# Access Compliance Report

## Public Rights-of-Way

### (Curb Ramps)

Intersection ID: 12900	Main Street: ARNOLD_DR	Cross Street: DRAPER_AV	Location: SE
ADA ID: FB03806CA696	Ramp Type: Para	Initial Pass/Fail: Fail	Overall Compliance: No
Codes/Mitigation Info/Possible Solution		Field Measurements/Component Compliance	
Severity Score: 33.75

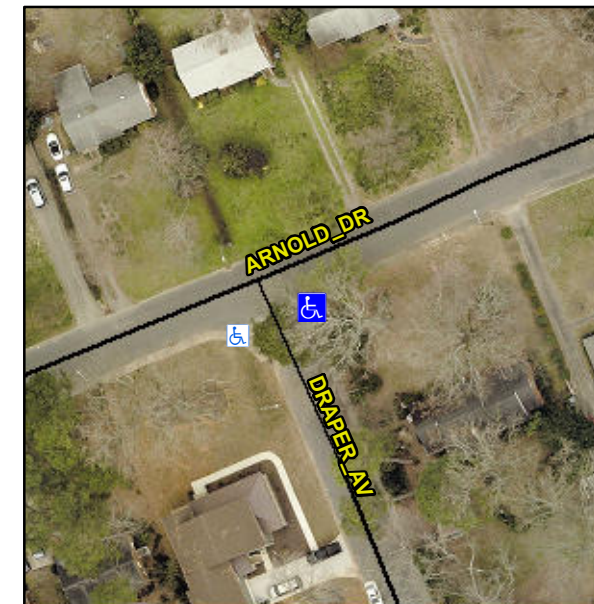
**LT RP < 5%**

**R304.5.1, R304.3.2**

Compliance	Description	Data	Compliance	Description	Data
N/A	Ramp Length LT (in)	57.0	N/A	Ramp Length RT (in)	61.0
No	Ramp Width LT (in)	44.0	No	Ramp Width RT (in)	44.0
Yes	Ramp Slope LT (%)	2.8	No	Ramp Slope RT (%)	12.3
Yes	Ramp XSlope LT (%)	1.5	Yes	Ramp XSlope RT (%)	1.7
N/A	Landing Length (in)	N/A	N/A	DWS Provided?	N/A
N/A	Landing Width (in)	N/A	N/A	DWS Contrast?	N/A
N/A	Landing Slope (%)	N/A	N/A	DWS Length (in)	N/A
N/A	Landing X Slope (%)	N/A	N/A	DWS Full Width?	N/A
N/A	Landing Curb? (Y/N)	N/A	N/A	DWS Offset (in)	N/A
N/A	Shared Landing?	N/A			
N/A	Gutter Ponding?	N/A	N/A	Gutter Slope (%)	N/A
N/A	Gutter Lip Ht (in)	1.5	N/A	Gutter X Slope (%)	N/A
N/A	Painted X Walk1?	No	N/A	Painted X Walk2?	N/A
	X Walk 1 Direction	To W		X Walk 2 Direction	N/A
N/A	X Walk 1 Width (in)	N/A	N/A	X Walk 2 Width (in)	N/A
	X Walk 1 Slope (%)	7.1		X Walk 2 Slope (%)	N/A
	X Walk 1 X Slope (%)	0.9		X Walk 2 X Slope (%)	N/A
N/A	Ramp inside XWalk1?	N/A	N/A	Ramp inside XWalk2?	N/A

**Remove & Replace Entire Ramp.**
